Re: Notice of Intent for 199 Gardner Street, West Roxbury
Additional Information per Conservation Commission request
Boston, MA

Howard Stein Hudson is providing Civil Engineering services for the proposed development at 199 Gardner Street in the West Roxbury neighborhood of Boston, Massachusetts.

NOI Permit Set dated 02-17-2021 was submitted as part of a Notice of Intent package to Boston Conservation Commission (BCC). BCC requested additional information related to the wetlands located north west of the property. Those comments were addressed, and additional information is provided:

RE: Updated Wetland Resource Evaluation and Resource Area Analysis, 199 Gardner Street,
West Roxbury, Massachusetts

199 Gardner Street - Site Preparation Plan

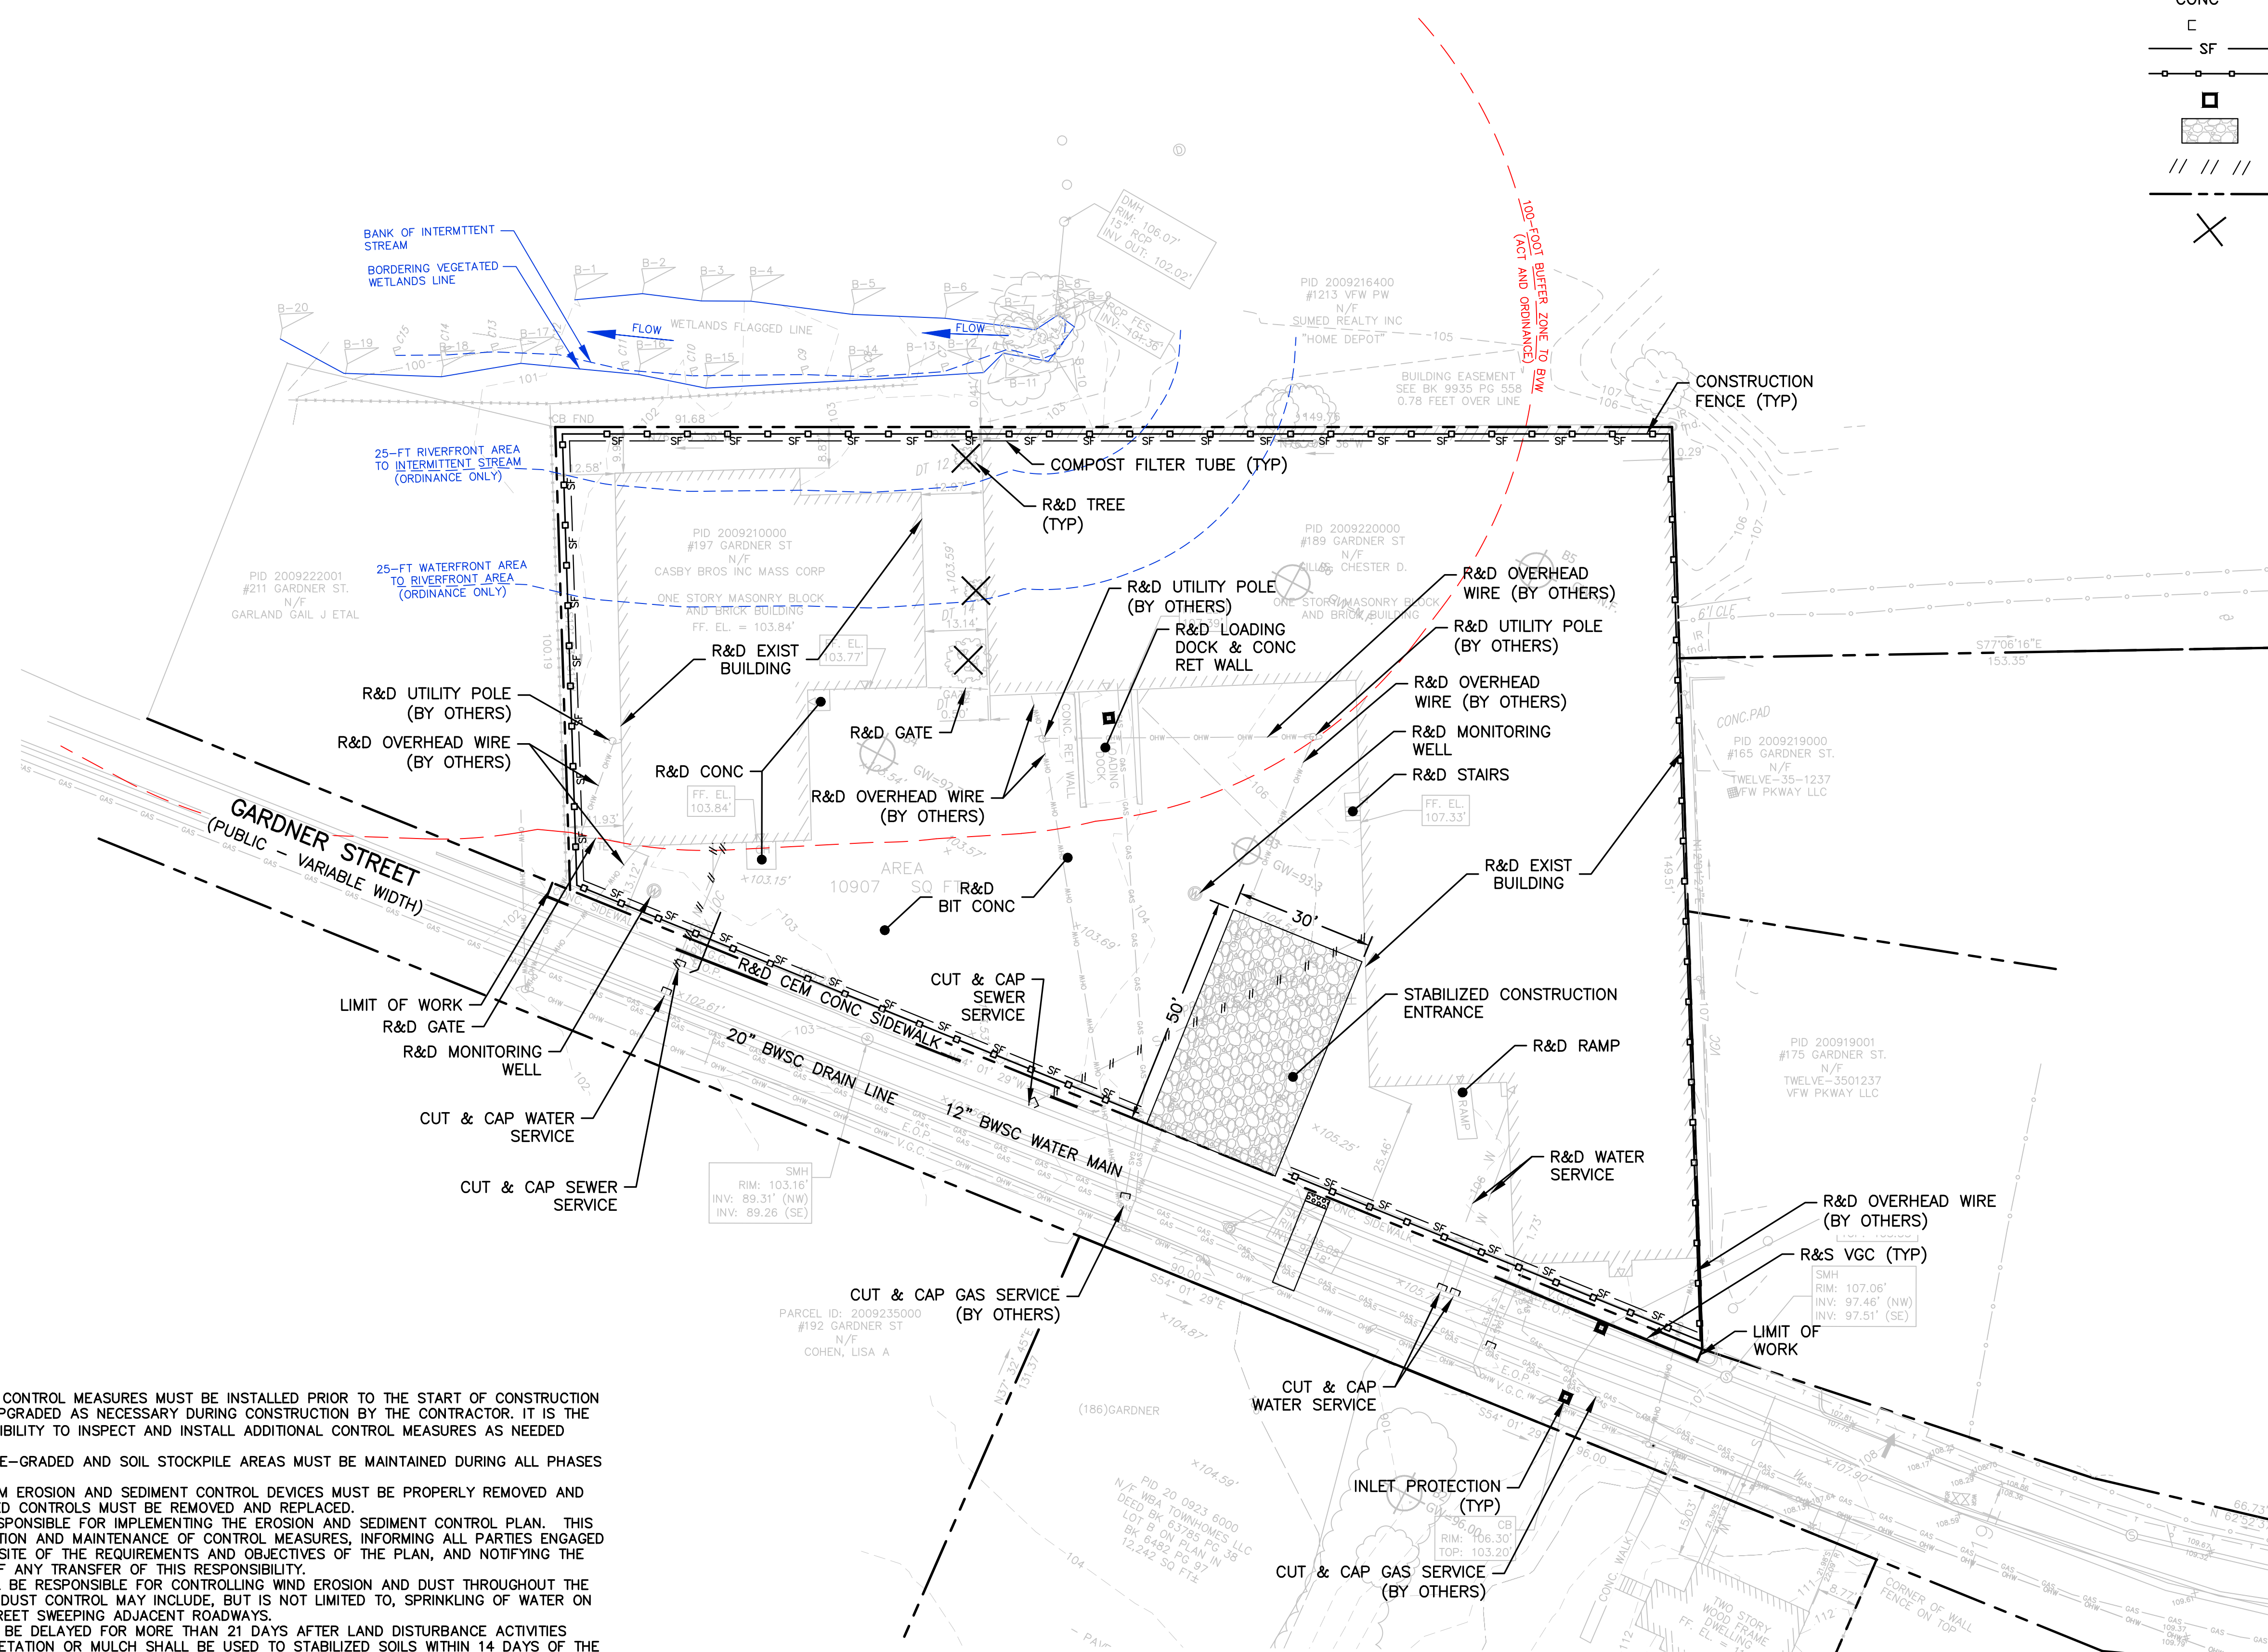
The bank of an intermittent stream associated with a Home Depot drainage outfall located north west of the property was delineated by a wetland scientist, surveyed, and shown on the plans. Under the latest issue of the Boston Ordinance intermittent streams are conveyed Riverfront Area, and Waterfront Area. Stream Bank, BVW, Riverfront Area, Waterfront Area and a 100-foot BVW Buffer are shown on updated plans as requested (See Attachment D).
